August 3, 2001

Re: Comments on Modification of Energy Star Window & Door Criteria to Satisfy
Current Building Energy Efficiency Codes

**COMMENTS ON
MODIFICATION OF ENERGY
STAR WINDOW & DOOR
CRITERIA TO SATISFY
CURRENT BUILDING ENERGY
EFFICIENCY CODES**

Attachment 1

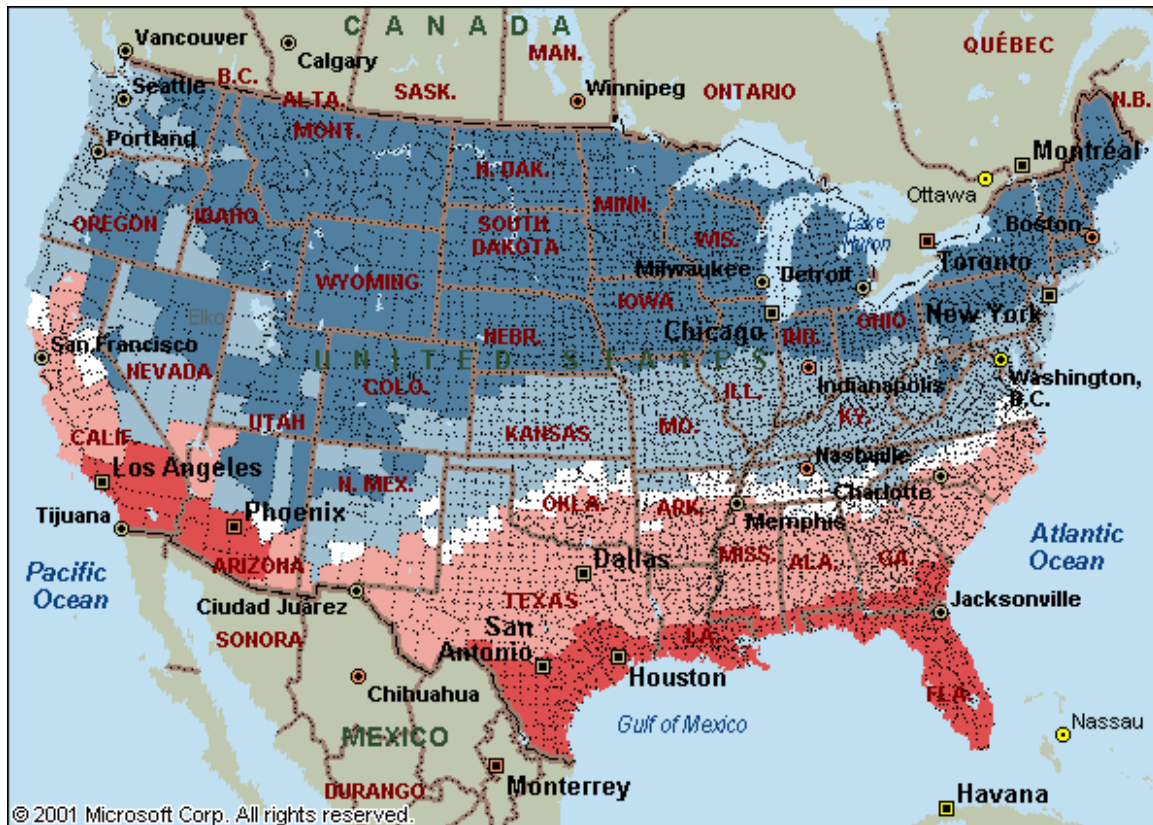
For simplicity, the easiest comparison to the IECC can be made by looking at the IECC additions and replacement window prescriptive requirements (in Chapter 5), which are diagrammed in the color-coded map in **Attachment 1**. The existing IECC maximum 0.4 SHGC requirement (for new homes, in additions, and as replacements) is mapped out in **Attachment 2**.

In the southern parts of the existing ENERGY STAR Central zone, there is also a big difference in U-factor requirements when compared to the IECC. Under the IECC, as indicated in **Attachment 1**, U-factors up to 0.75 are permitted only in Florida, in the southernmost parts of California, in southwest Arizona, and in the southern ¼ of Texas, Louisiana, Mississippi, Alabama and Georgia. Current ENERGY STAR requirements allow the 0.75 U-factor requirement to extend further to almost all of Texas (except the panhandle), the southern edge of New Mexico, all of Louisiana, and half of Mississippi, Alabama and Georgia. As a result, we recommend lowering the Southern line to

Under the IECC, as indicated in **Attachment 1**, U-factors up to 0.75 are permitted only in Florida, in the southernmost parts of California, in southwest Arizona, and in the southern ¼ of Texas, Louisiana, Mississippi, Alabama and Georgia. To match the IECC, we propose that the Southern line be lowered as indicated in **Attachment 3**, which is also consistent with our recommendations above for the Central zone and with the IECC.

Attachment 2

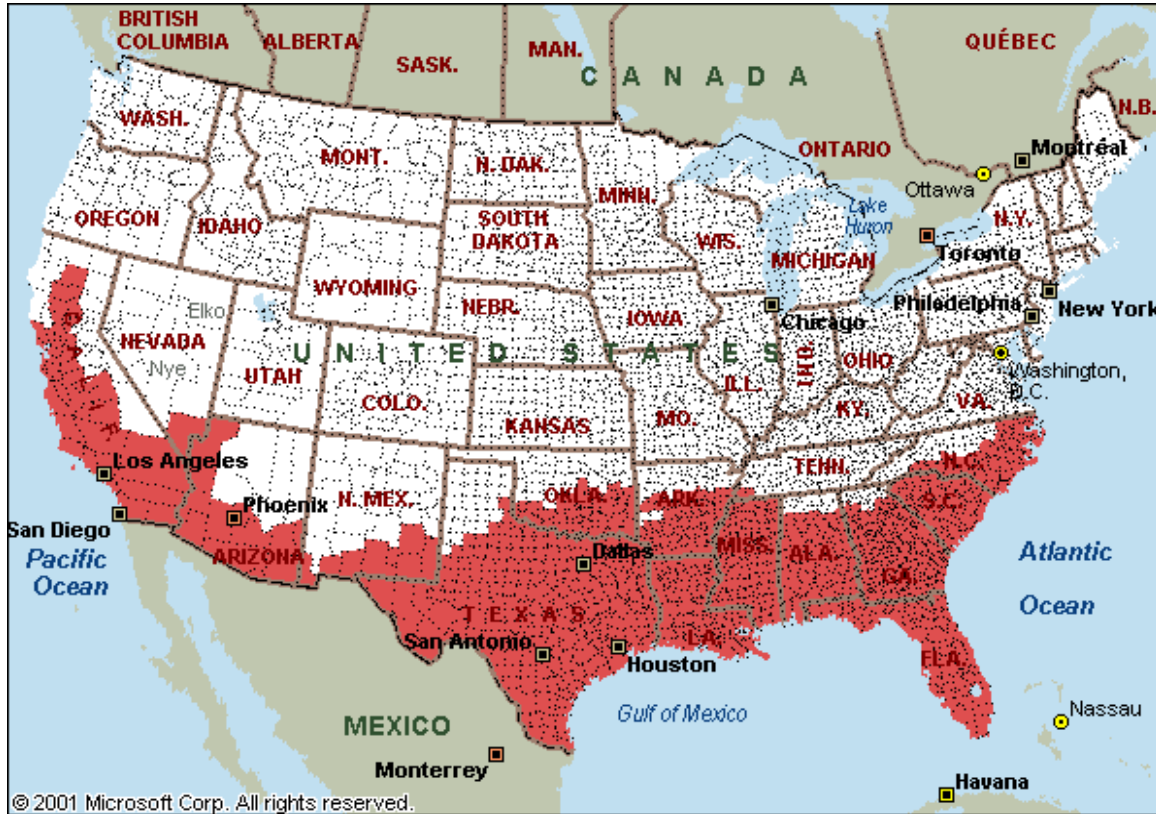
When comparing IECC to ENERGY STAR, the IECC requires the 0.4 maximum SHGC in many more climate zones. Areas that are, for the most part, currently missed by ENERGY STAR and captured by the IECC 0.4 SHGC requirement include, Oklahoma, Arkansas, South Carolina, and most of North Carolina. The IECC's 0.4 SHGC also extends to much larger portions of California, Mississippi, Alabama and Georgia. (See **Attachment 2.**)

Attachment 3

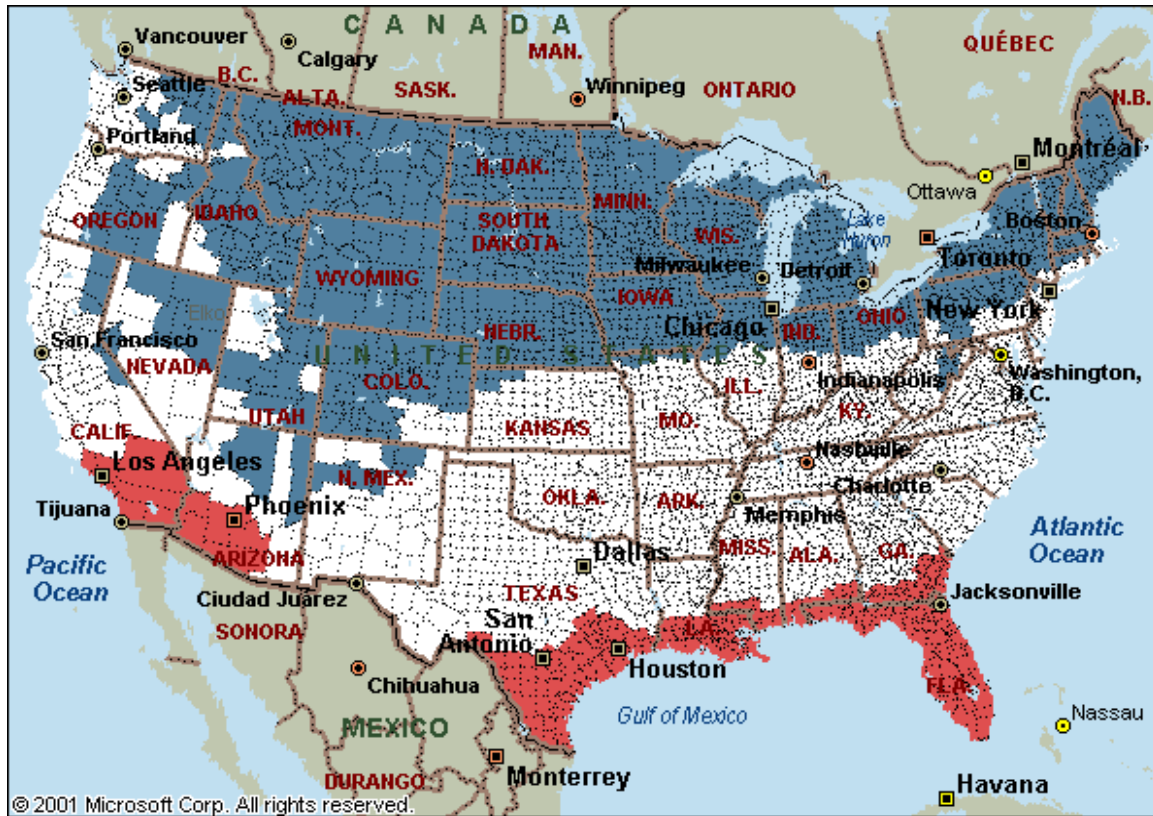
require a 0.40 maximum U-factor in all but the southernmost portions of the U.S. Thus, cities like Charlotte, Dallas, Las Vegas, Memphis, and Washington, DC, which all could greatly benefit from both heating and cooling savings attributable to low U-factors and SHGCs, would be appropriately positioned under such new ENERGY STAR criteria. (See **Attachment 3**).

To catch up to the IECC, ENERGY STAR could revise its standards to have the following breakdown (A map of these proposed ENERGY STAR requirements to match the IECC is in **Attachment 3**):

ENERGY STAR Zone	HDD	U-factor	SHGC	Air Leakage
Northern	6,000 and above	0.35	Any	0.3 cfm/ft ²
Central	2,000 – 5,999	0.40	0.40	0.3 cfm/ft ²
Southern	1,999 and below	0.75	0.40	0.3 cfm/ft ²
